Commonwealth Edison

August 20, 1984

Subject: Byron Generating Station Units 1 and 2
Braidwood Generating Station Units 1 and 2
Instrumentation for the Detection of
Inadequate Core Cooling
NRC Docket Nos. 50-454/455 and 50-456/457

ICC DETECTION INSTRUMENTATION
SENSORS, PROCESSING AND DISPLAY
(SHEET 1 OF 2)
FIGURE 3-1

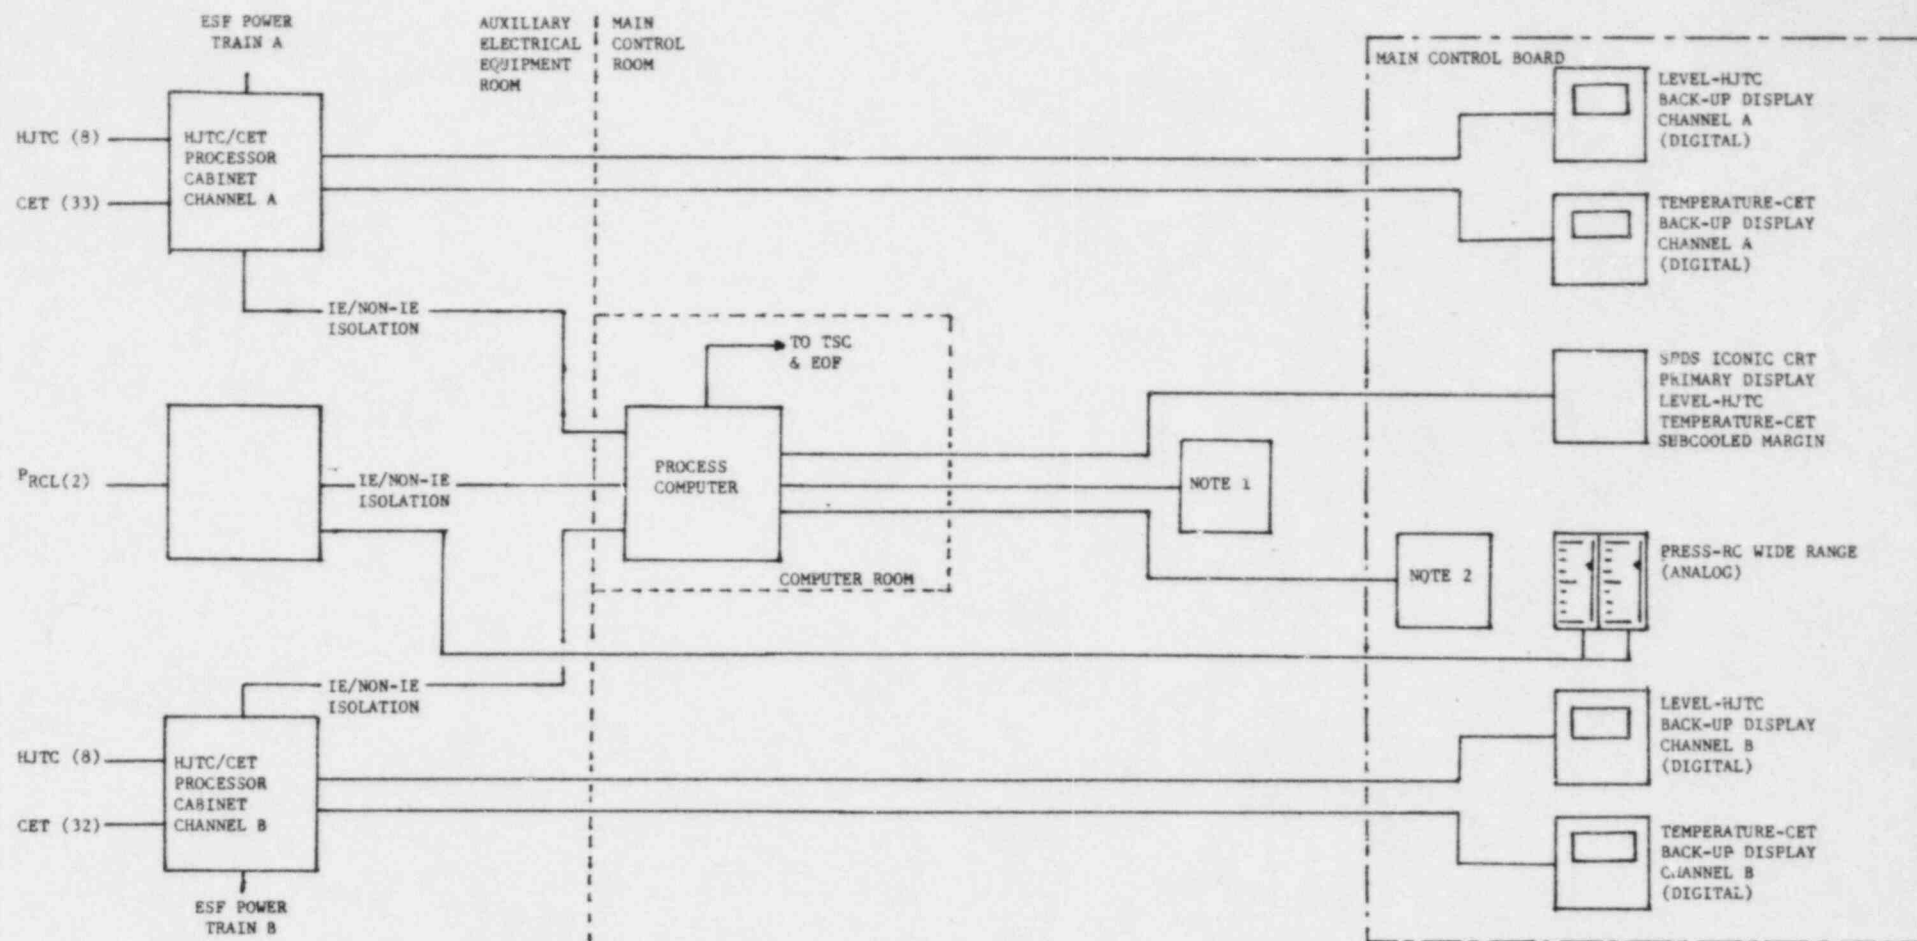
One minor correction is necessary to the information presented in reference (b) regarding display of the subcooling margin. Attachment A to that letter indicated that the subcooling would be constantly displayed on the wide range SPDS iconic. Actually, the normal display is via the narrow-range SPDS iconic. The wide range iconic is displayed after a reactor trip.

Additional information regarding various displays of subcooling is provided in Figure 3-1 enclosed with this letter. This figure is similar to Figure 3-1 in reference (a), but it contains more detail regarding the various process computer displays and instrument input signals.
